# UNITED STATES PATENT AND TRADEMARK OFFICE

APPLICATION NO.	FILING DATE	FIRST NAMED INVENTOR	ATTORNEY DOCKET NO.	CONFIRMATION NO.
10/060,862	01/30/2002	Michel Gau	HOE-676	6870

<b>Office Action Summary</b>	Application No.	Applicant(s)	
	10/060,862	GAU, MICHEL	
	Examiner	Art Unit	
	Cheryl Miller	3738

Fig. 1

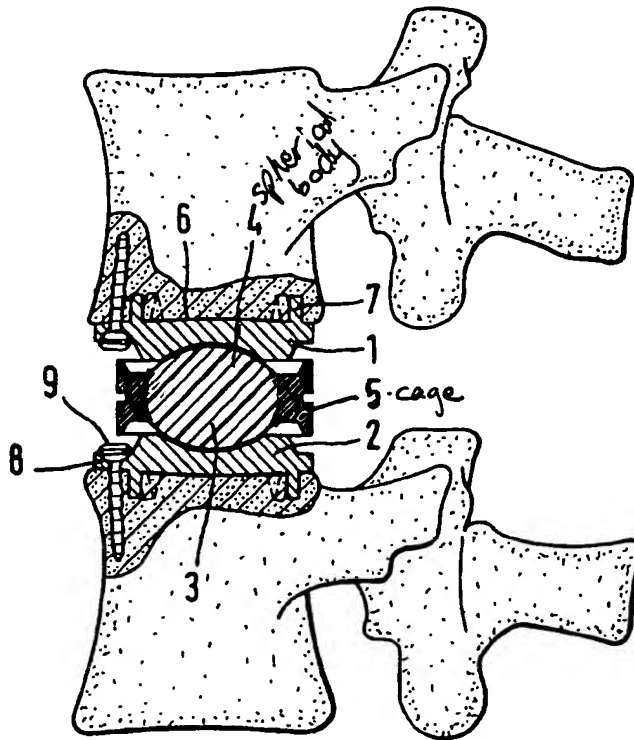
Claims 23 and 24 are rejected under 35 U.S.C. 102(b) as being anticipated by Buttner-Janz (US 5,556,431). Buttner-Janz discloses a prosthesis (core 3) *adapted* to replace a nucleus of an intervertebral disc (is sized to fit within a nucleus) comprising a cage (rim 5; see attachment 1, seen in red) of substantially planar shape and at least one spherical body (4, see attachment 1, seen in yellow) disposed non-displaceably in the cage (5; body is not displaceable within the cage 5) and freely rotatable (body 4, is rotatable, when rotating, it rotates the entire prosthesis) about its center so as to be movable in two directions in the plane of the cage (movable to rotate clockwise and counter-clockwise), the spherical body (4) made of a substantially rigid, non-oxidizing, biocompatible material (col.2, lines 40-41) and having a diameter greater than the planar thickness of the cage (fig.1), and is adapted to protrude from both opposite sides of the cage in the form of spherical caps (fig.1), and is adapted to fit within the annulus. Buttner-Janz discloses a spherical body which is not elastically deformable (col.2, lines 40-41; fig.1).
